REV.  
B

AS3404™

BOLT, MACHINE - HEXAGON HEAD,  
 DRILLED 6 HOLES, PD SHANK,  
 AMS5708 (UNS N07001), .1900-32 UNJF-3A

ISSUED 1985-08 REAFFIRMED 2006-10 REVISED 2022-03

FIGURE 1 - BOLT

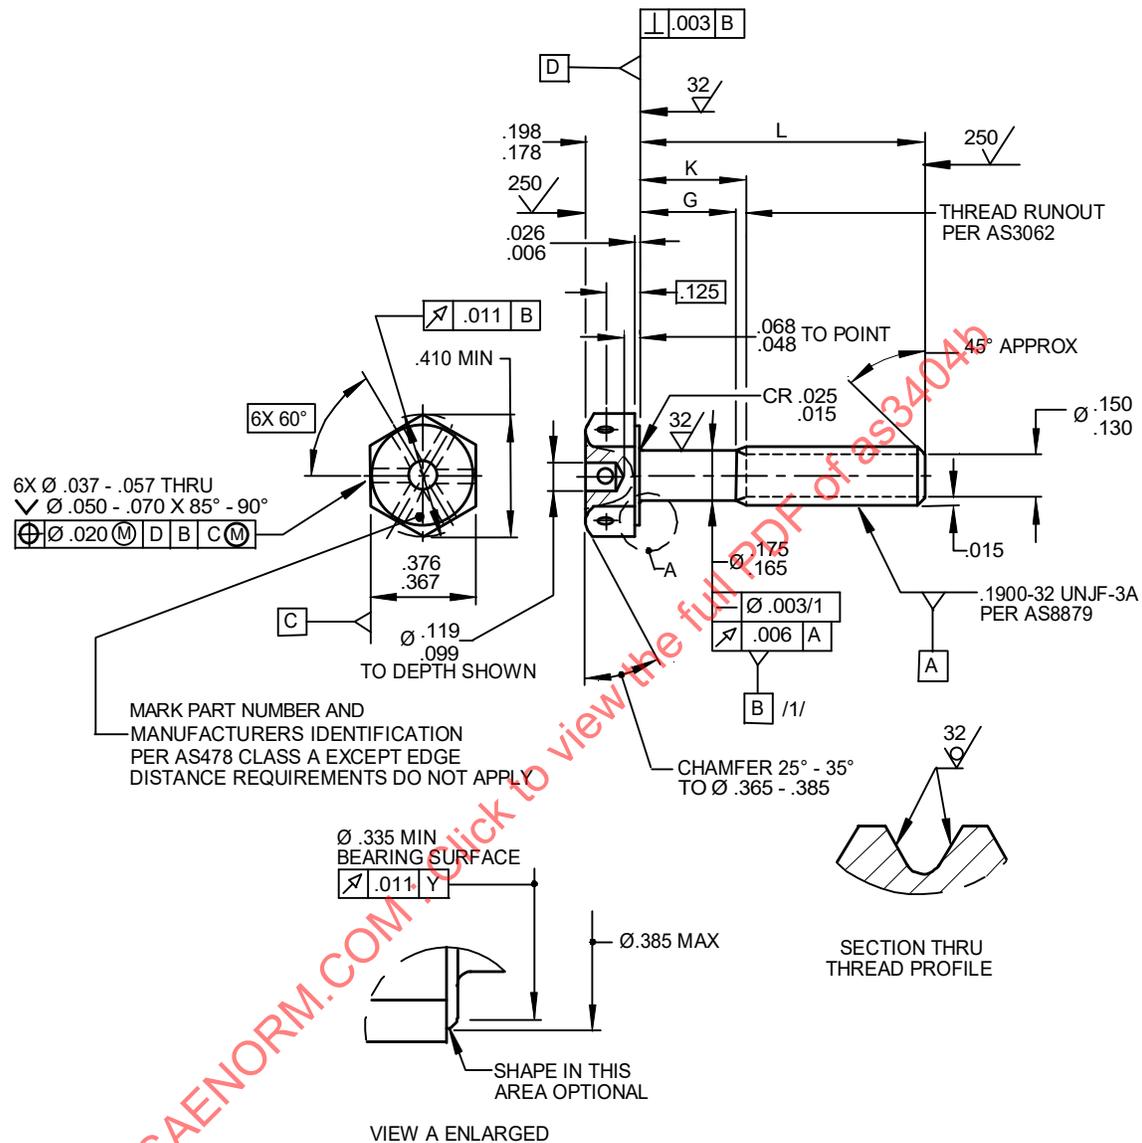
LEAD THREAD CHAMFER TO AS1132, UPDATE TO ASME Y14.5-2018, REVISE FILLET RADIUS TO CR, ADD USAGE NOTE, GENERAL EDITORIAL UPDATES.
